Access Compliance Report

Public Rights-of-Way

(Curb Ramps)

Intersection ID: 17092	Main Street: IRBY_DR	Cross Street: JAMESTON_DR	Location: NW
ADA ID: E93EB1433474	Ramp Type: BlendTrans2	Initial Pass/Fail: Fail	Overall Compliance: No
		Severity Score: 8.75

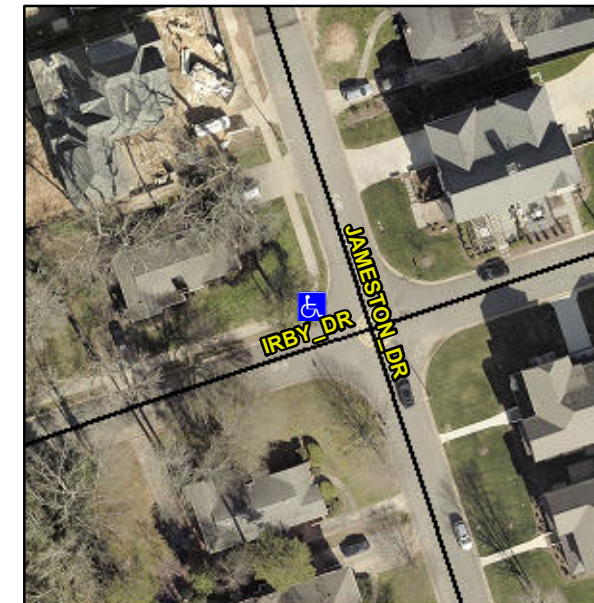
Not Found, R304.5.1

Compliance	Description	Data	Compliance	Description	Data
N/A	Ramp Length (in)	118.0	Yes	BlendTrans Slope (%)	3.1
No	Ramp Width (in)	46.0	Yes	BlendTrans XSlope (%)	1.9
N/A	Flare Type LT	N/A	N/A	Flare Type RT	N/A
N/A	Flare Slope LT (%)	N/A	N/A	Flare Slope RT (%)	N/A
N/A	Flare Traversable LT?	N/A	N/A	Flare Traversable RT?	N/A
N/A	Landing Length (in)	N/A	N/A	DWS Provided?	N/A
N/A	Landing Width (in)	N/A	N/A	DWS Contrast?	N/A
N/A	Landing Slope (%)	N/A	N/A	DWS Length (in)	N/A
N/A	Landing X Slope (%)	N/A	N/A	DWS Full Width?	N/A
N/A	Landing Curb? (Y/N)	N/A	N/A	DWS Offset (in)	N/A
N/A	Shared Landing?	N/A			
N/A	Gutter Ponding?	N/A	N/A	Gutter Slope (%)	N/A
N/A	Gutter Lip Ht (in)	N/A	N/A	Gutter X Slope (%)	N/A
N/A	Painted X Walk1?	No	N/A	Painted X Walk2?	No
	X Walk 1 Direction	To SE		X Walk 2 Direction	To NE
	X Walk 1 Width (in)	N/A		X Walk 2 Width (in)	N/A
	X Walk 1 Slope (%)	6.1		X Walk 2 Slope (%)	0.2
	X Walk 1 X Slope (%)	0.9		X Walk 2 X Slope (%)	7.4

N/A	Ramp inside XWalk1?	N/A	N/A	Ramp inside XWalk2?	N/A
	Road Slope (%)	2.2		Clear Space?	N/A
	Road X Slope (%)	5.4	N/A	Clear Space to XWalk (in)	N/A
N/A	Any Obstructions?	N/A	N/A	Storm Grate/Utility Hazard?	N/A
	Obstruction Type			Storm Grate/Utility Type	
		N/A			N/A
			Yes	Surface Condition? (G/P)	Good
			No	Curb Slope (%)	12.4

Remove & Replace Curb Ramp With Two New Directional Ramps or Equivalent.
